Access Compliance Report Public Rights-of-Way (Curb Ramps)

Intersection ID: 10025871 Main Street: ELEVATION POINT DR Cross Street: N/A Location: SE Initial Pass/Fail: Fail **Overall Compliance: No Severity Score:** 12.5 ADA ID: F4CFA9C50B5D Ramp Type: Perp

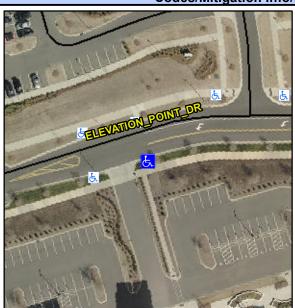
10.4

Ramp Slope (%)

ELEVATION POINT DR Street 1 Name Stop Condition-Street 2 None N/A Street 2 Name Stop Condition-Street 1 N/A Possible Solutions: Remove & Replace Entire Ramp. Surveyor Notes: N/A PROW/ADA: R304.2.2
